Kings Park Metal Recovery and Recycling Facility Expansion (SSD-10396)
Request for additional information

Attachment 1 – Department's comments

Attachment 2 – Noise – Department's comments

Figure 1: Noise contours and assessment locations presented in the ANIA

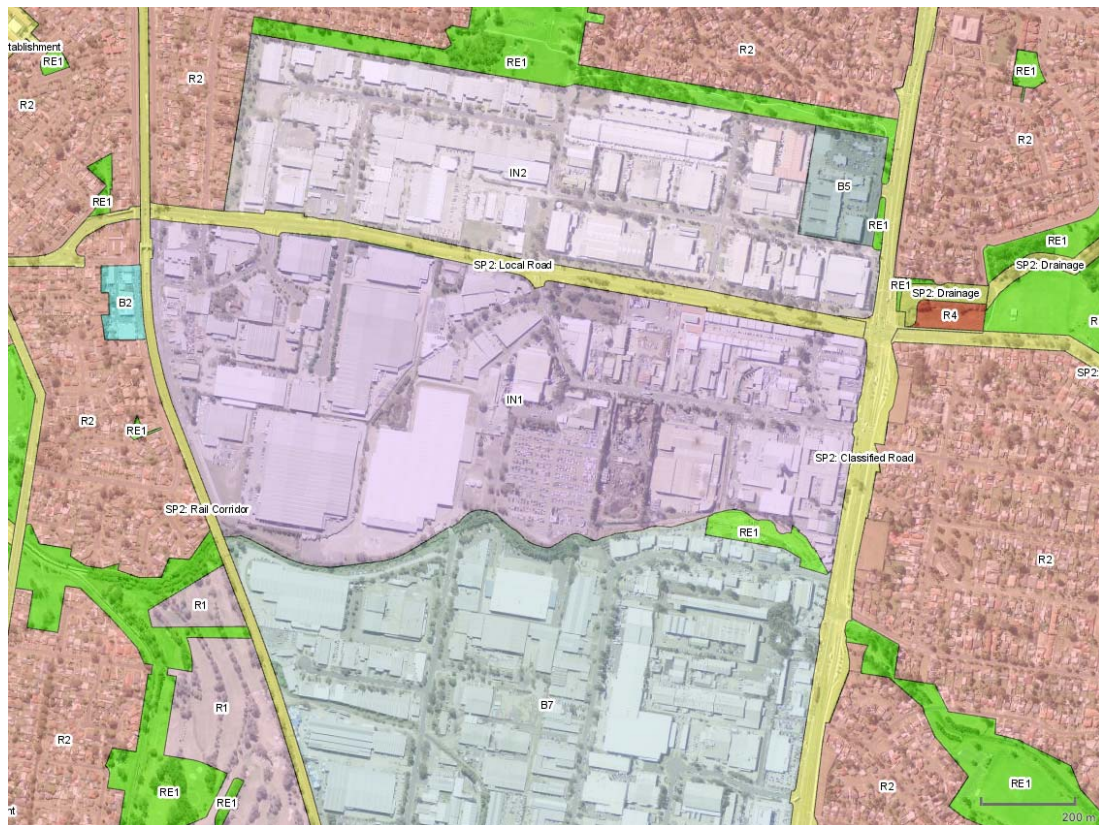
The Addendum Noise Impact Assessment (ANIA) provided as part of the RTS has not addressed issues raised by the Department as operational noise and background noise were only assessed at 2 Anthony Street (denoted as Receiver R1B in the ANIA) and 187 Sunnyholt Road (denoted as Receiver R1A) in the wider catchment area of Blacktown and Kings Langley. The Department considers there is the potential for residences east of Charles Street that are located on higher ground and situated further away from the subject site to be more noise affected than the closest residences fronting Sunnyholt Road. The Department's previous comments on the EIS specifically requested noise contours be provided to establish operational noise levels for residential receivers from Sunnyholt Road to the highest location above sea level along Anthony Street, covering an assessment radius of around 700 metres from the eastern site boundary. However, the ANIA has not provided noise contours east of Charles Street (see **Figure 1**). Further to this, the additional background noise data across the Blacktown catchment area requested by the Department in 2020 is also missing in the ANIA. Unless the most affected receiver and the subject site are setback from the road at comparable distances and similar sound propagation conditions, background noise monitoring near Sunnyholt Road must be avoided as background noise levels measured near Sunnyholt Road can be much higher than a location that is situated further away fronting local streets. It is evident from the noise monitoring results collected at the side yard of 2 Anthony Street and front yard of 187 Sunnyholt Road that rating background noise levels are highly sensitive to a range of physical factors (see above list) for which the measured levels were found up to 10 dB lower at the location with no direct line-of-sight to Sunnyholt Road.

The Department requires additional background noise monitoring data be provided at a representative location along Anthony Street, east of 16 Anthony Street, Blacktown. In addition, operational noise contours must be updated to include all residential receivers from Sunnyholt Road to the highest location above sea level along Anthony Street, covering an assessment radius of no less than 700 metres from the eastern site boundary.

- The ANIA has not considered all relevant receiver types identified in Table 2.2 of the NPfl. For example, the most affected receiver in the B7 Business Park zone has been defined as 'industrial premises' instead of 'commercial premises' for noise assessment purposes (see **Figures 1 and 2**). The Department notes the cumulative $L_{Aeq,period}$ amenity noise level of 70 dB(A) would apply to industrial premises located in an area defined as an industrial zone such as IN1 whereas the cumulative $L_{Aeq,period}$ amenity noise level of 65 dB(A) would apply to commercial premises in a planning zone that allows for commercial activities. The Department requires the noise assessment be updated to include all relevant receiver types.

2. Operational noise survey and modelling
- Noise contours shall be updated to display a single decibel value instead of a range of decibel values for each contour line (see **Figure 1**).
